**METROPOLITAN GOVERNMENT OF NASHVILLE AND DAVIDSON COUNTY**

**STAFF RECOMMENDATION**  
**1232 Lillian Street**  
**June 20, 2012**

**Application:** Demolition; Infill  
**District:** Lockeland Springs-East End Neighborhood Conservation Zoning Overlay  
**Council District:** 06  
**Map and Parcel Number:** 08313014500  
**Applicant:** Jamie Pfeffer, Architect  
**Project Lead:** Sean Alexander, sean.alexander@nashville.gov

1 SITE PLAN  
 SCALE 1/16" = 1'-0"

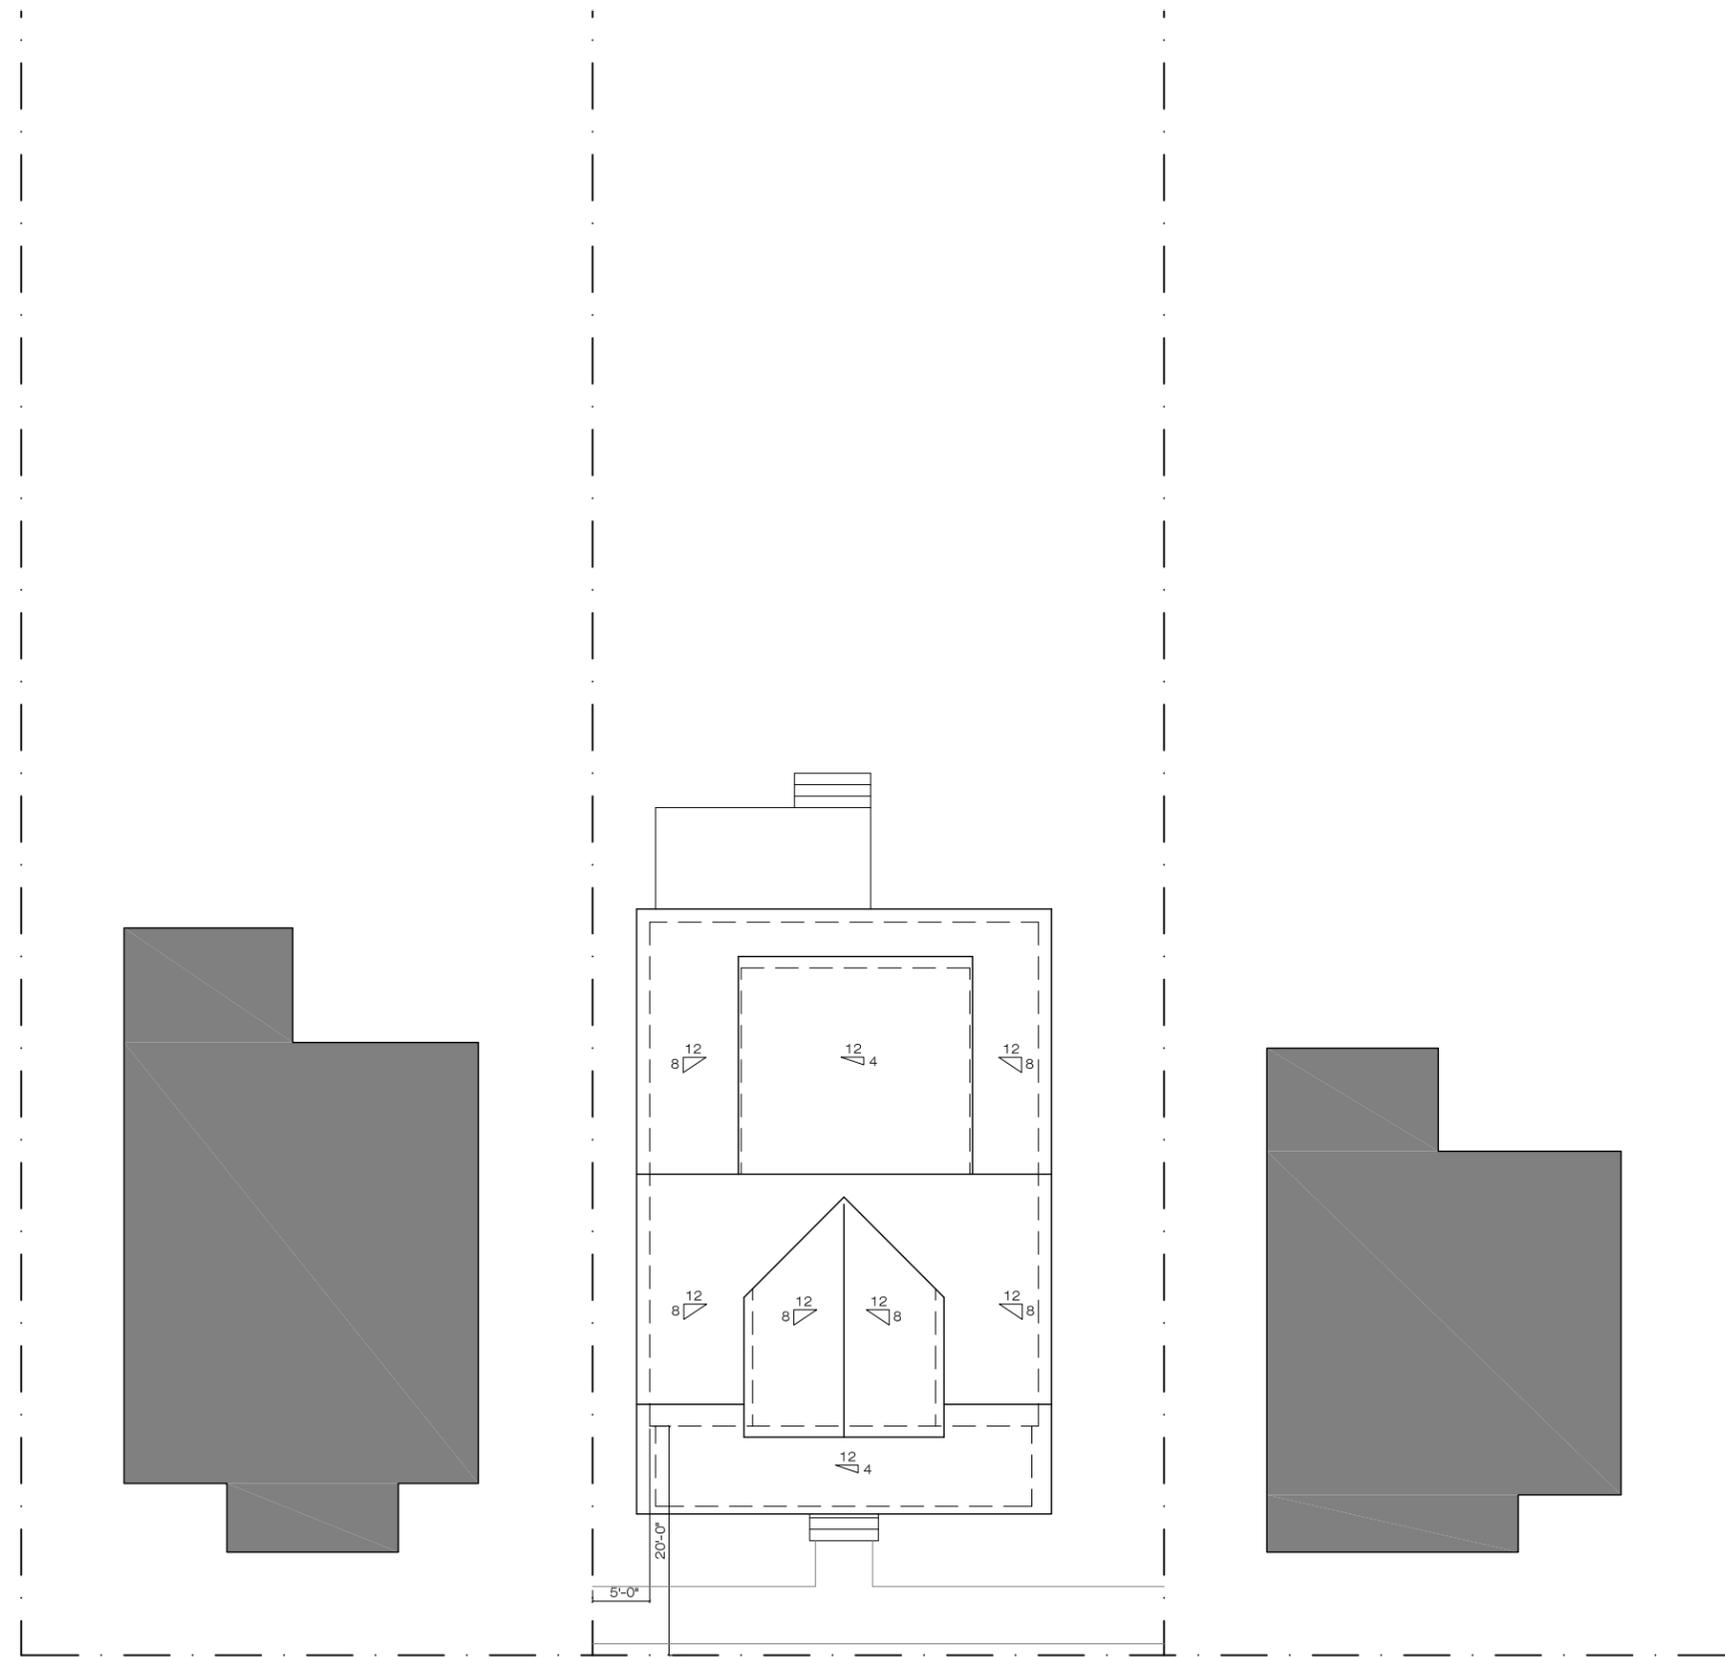
The property is not bounded on the rear by an alley, so a driveway will be added to the right of the new structure; however it is not shown on the site plans. Staff recommends a new site plan showing the location and materials for the driveway and the location of mechanicals. The driveway should be concrete strips, at least to the front wall of the house and should continue to at least the rear of the house. The mechanicals should be located on the opposite side, towards the rear of the house, so that they will not interfere with the driveway. There will also be a concrete walkway leading from the right-of-way to the front of the house. With these conditions, the locations of these appurtenances is appropriate and meet guideline II.B.9.

Staff recommends approval of the demolition of the non-contributing structure and the proposed new infill with the conditions that staff review final details for windows, doors and roof color and the applicant submit a site plan showing the location and materials of the driveway and mechanicals. With these conditions, the application meets the applicable design guidelines for the Lockeland Springs-East End Neighborhood Conservation Zoning Overlay.
